Committee of Experts on the Transport of Dangerous Goods and on the Globally Harmonized System of Classification and Labelling of Chemicals

Sub-Committee of Experts on the Transport of Dangerous Goods

Stacking test

Transmitted by the expert from Spain*

- 6.5.2.2.2 “The maximum permitted stacking load applicable shall be displayed on a symbol as shown in Figure 6.5.1 or Figure 6.5.2. The symbol shall be durable and clearly visible.

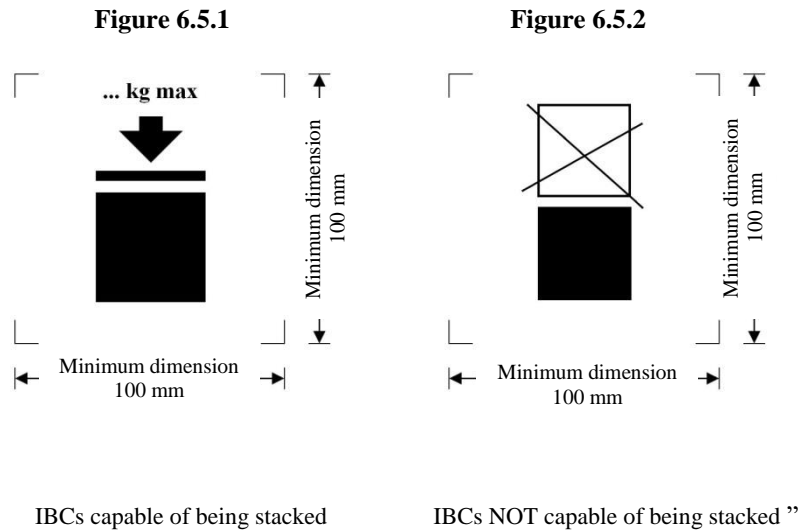
8. The most fundamental change is referring to the superimposed stacking mass instead of referring to the test load. This is coherent as in the stacking mark reference is done to kg that are to be stacked on top. The mark shown in figure 6.5.1 and figure 6.6.1 is very intuitive; it shows the maximum mass that can be stacked on the IBC or large packaging during transport. This mark is not modified, only the language of the text referring to it.

“The maximum permitted **superimposed stacking mass** ~~load~~ applicable shall be displayed on a symbol as shown in figure 6.5.1 or figure 6.5.2. The symbol shall be durable and clearly visible.”
